The District of North Vancouver REPORT TO COUNCIL

September 21, 2021
Case: PLN2020-00040
File: 08.3060.20/040.20

**SUBJECT: DEVELOPMENT VARIANCE PERMIT 40.20 (Coach House) –
1061 Handsworth Road**

Dominic Sy Architect 22 West 80th Ave Vancouver BC V5X 1Z4			
L1 Residence Passive House and Coach House 1081 Handsworth Rd			
Site Plan			
Drawn By:	DS	Project No.:	2002
Check By:	DS	Scale:	1" = 10'
Appr. By:	DS	Sheet No.:	1 of 1
DWG 10-2002-01

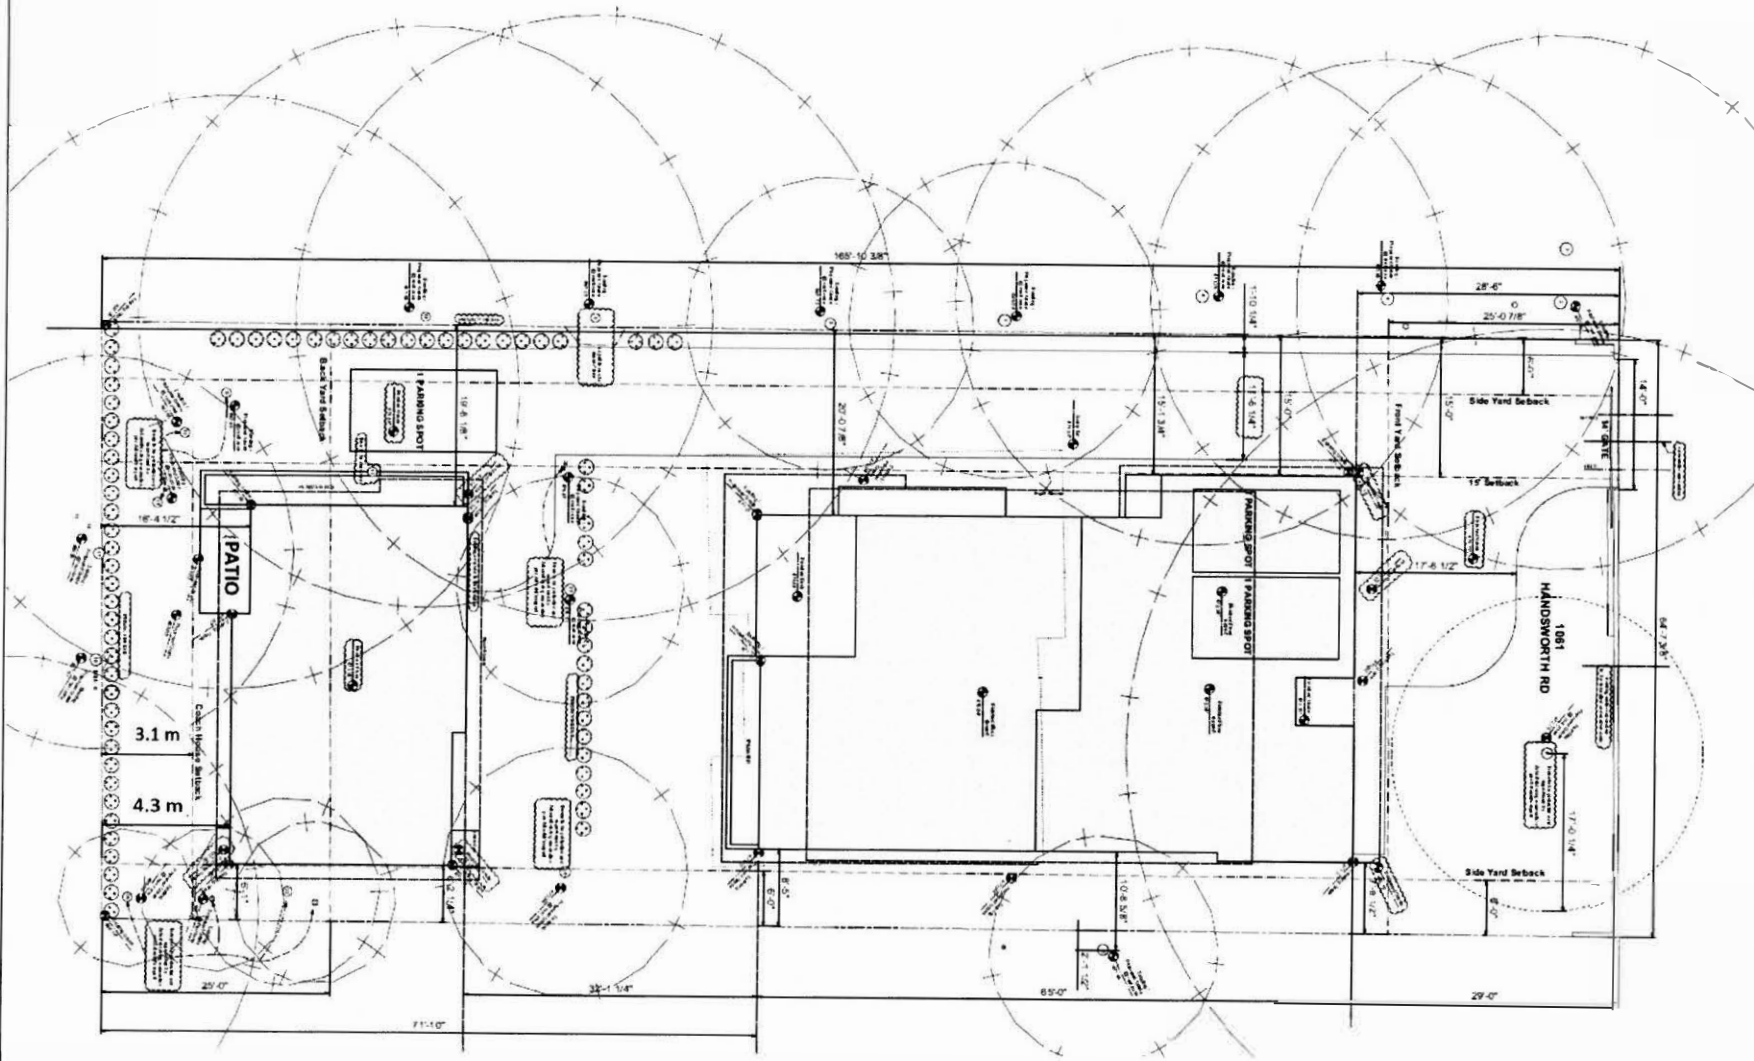
1. Overall I find the information package sent for review is of insufficient quality for the general public to make informed comments on. For example the rear yard setback dimension is illegible, no dimensions are indicated at all for the east and west setbacks and the location of the existing landscaping to be removed is not indicated. I will assume that the rear yard setback is a minimum of 10 feet but I do worry that this distance will negatively impact the trees to be retained and the trees on my side of the existing fence. New landscaping is not indicated which also limits useful comment.

I state again the rear yard setback in any of the over 90 coach houses I have personally toured in the City of Vancouver, City of North Vancouver, Surrey and Seattle have never been used as private outdoor space for the coach house. In all cases that I have seen the area between the main house and the coach house is the area that is divided up and screened appropriately for the use by the owner and the tenant as personal spaces. I am not aware of any examples where this is not the case and believe this to be the "best practice" for this design element regardless of whether or not this is expressed in the current DNV design guidelines. Perhaps you can cite some examples otherwise?

- installation of hedges along the existing fence across the rear property line;
- installation of hedges along the west property line and a planter box on the west side of the coach house patio area;
- retention of trees located at and near the rear and west property lines; and
- re-location of the coach house entrance to the north side of the coach house (previously this was on the west elevation).

Staff provided the applicant's revised plans to the neighbour who had commented and after reviewing the revised plans, the neighbour submitted a second response which maintained concerns with privacy. Staff responded to clarify that the private outdoor space (patio) is not within the required setback areas of the property nor is any proposed infrastructure. Staff advised the applicant of the continued concerns. The applicant has made no further changes to the coach house design as they note that several steps have already been taken to help address concerns.

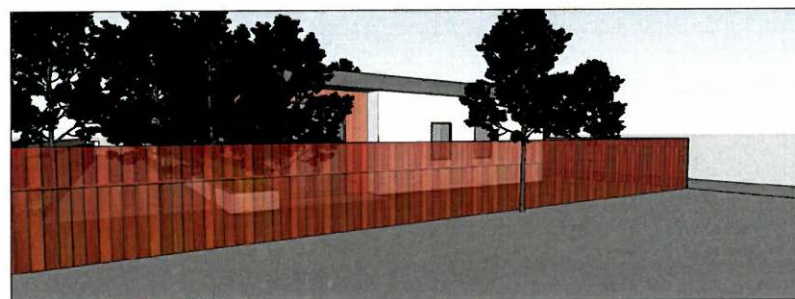
2. With respect to the design of the coach house I do not find it to be following the design guidelines provided. Specifically , the coach house entry/front door is not visible from the street as it should be. The current location would seem to indicate the intention to use the rear yard of the coach house as private space for the occupants. I do not believe this is within the spirit in which coach housing has generally been supported. It has been my observation from the several tours of coach housing I have been on in Vancouver, Burnaby, and City of North Van that the space between the coach house and the main house is to be divided up and shared so as to minimize the visual and noise impacts on the surrounding neighbours. Because of the poor quality of design and poor reproduction it is not possible to know exactly what is intended for sure but it seems pretty obvious that the intention is to establish 2 separate private yards. One for the main house and one for the coach house. This opinion is further supported by examining the number and location of windows in the coach house which presents a blank wall to the main house and puts larger windows facing my property to the south. The current design maximizes the loss of privacy not only to [REDACTED] [REDACTED] and maximizes the privacy for the owner and the tenant. Not really my understanding of the Guidelines.

Otherwise I recommend that the proposed front door be moved from the SW corner to the NW corner; the secondary door moved to the south elevation and the 2 windows on that elevation be changed to clerestory windows or to be shown with obscured glazing.

I would like to see the door on the north elevation relocated to the northwest corner of the west elevation. In its current location on the north elevation it is obvious, even without seeing the landscape plan, that this setback area is intended to be used by the tenant to the benefit of the owner and the [REDACTED]. You note that having this outdoor space north of the coach house could create privacy issues between the tenant and the owner which I find a spurious argument. The owner is getting a huge benefit by being allowed to build the coach house and should not be able to transfer this loss of privacy to [REDACTED]. Again, I take exception to your use of section 6.3 to try and justify the use of the required setback area for private outdoor space. This guideline is clearly intended to reference the outdoor space shared by the owner and the tenant. Not the tenant and the neighbour. If the coach house has to move 4 feet closer the p/I so be it. But there should not be any recreational use made of the setback area by the occupants.

I really think this is a very poor design and certainly not up to the high standards the District demands of its developers. Really there should be an entry door to the coach house off the parking space and the double doors on the south elevation moved further east to open into the private outdoor space that shared with/divided up with the occupants of the main house. The proper door location would be made easier if the floor plan included room layouts but in that absence I believe this is the most appropriate locations for the doors.
